Appendix E Initial Alternatives Summary
Comments from Days 1 and 2

Gambell Street Redevelopment and Implementation Plan

Public Input from Days 1 and 2 of the Public Charette (May 21-22, 2013)

Corridor Cross-Section Option S1A

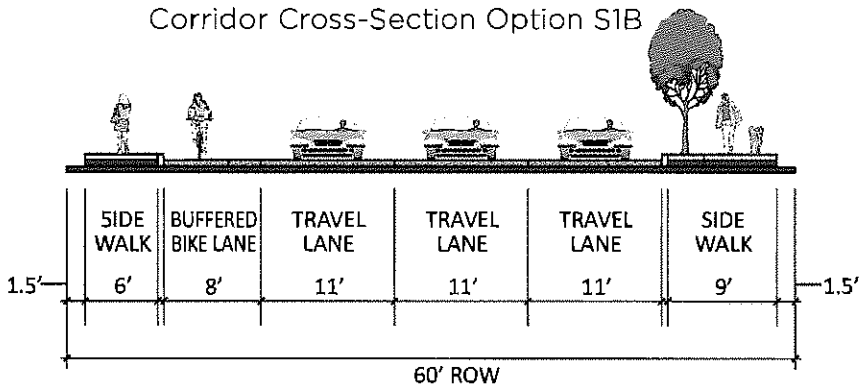
Recommendation	Agree	Disagree	If disagree, what would you change?	Rank
	X		Not sure abt bike lane but landscaping on road side good for pedest

Corridor Cross-Section Option S1A

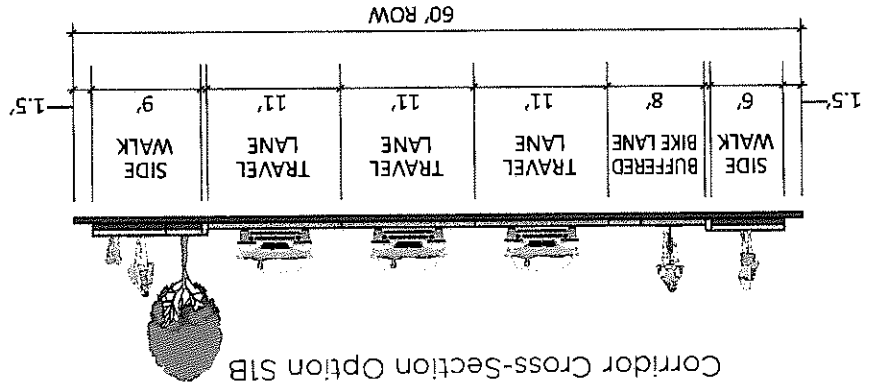
red. cur storage

Corridor Cross-Section Option S1E

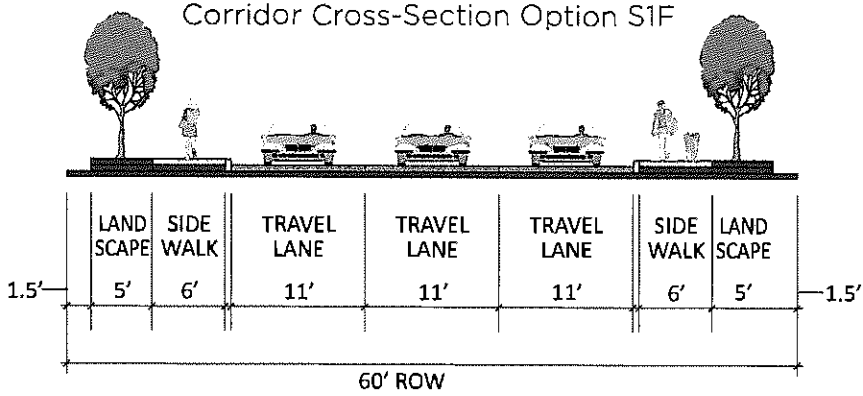
Recommendation	Agree	Disagree	If disagree, what would you change?	Rank
		/	make green

Exhibit 1: Existing Cross-Section

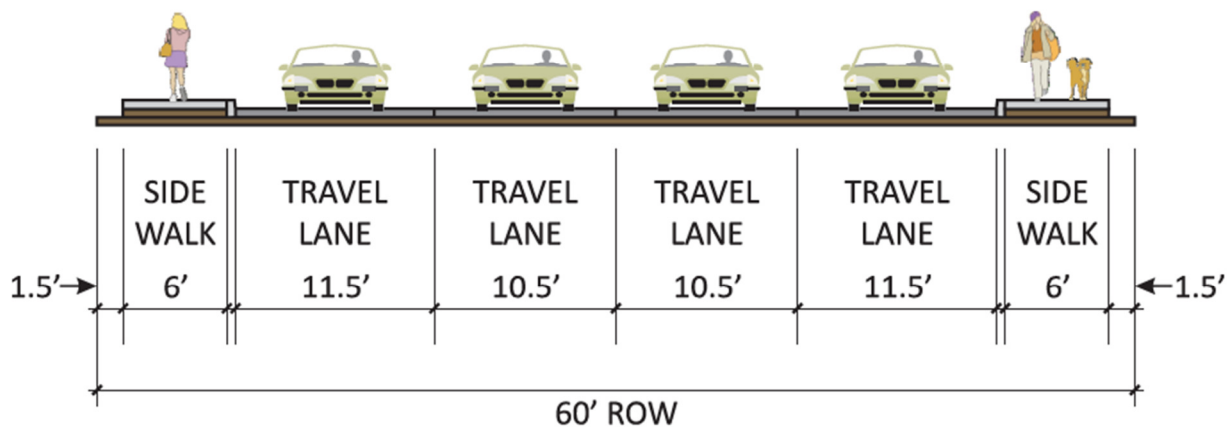
As seen in the exhibit, there is currently no allowance made for snow storage and little separation between pedestrians and vehicles. In order to improve the streetscape of the roadway, the Gambell Street Redevelopment and Implementation Plan has assessed other potential cross-sections. Based on
